#### IEEE P802.1Qdj Status Overview

## IEEE P802.1Qdj – Status Overview

#### 1 46.2.3.8 StreamStatus

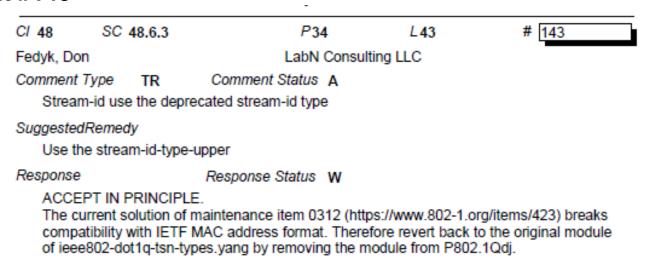
C/ 46 SC 46.2.3.10 P27 L13
Ferreira Coelho, Rodrigo Siemens AG

The state "modified" must be removed: the properties of a stream in state modified does not correspont to the properties of the respective established stream, i.e. CNC view != network view. This condition must not occur.

Remove state "modified"

ACCEPT IN PRINCIPLE.

The state "modified" is required by the RPC "ComputePlannedAndModifiedStreams". So the CNC knows which Streams have been modified and should be computed, triggered by this RPC.

Change 46.2.3.10 as follows:

"StreamStatus provides the status of a Stream. The status is maintained by the CNC and is used to determine which Streams are computed by calling the RPC

ComputePlannedAndModifiedStreams (46.2.7.2).

StreamStatus uses the enumeration specified in Table 46-12."
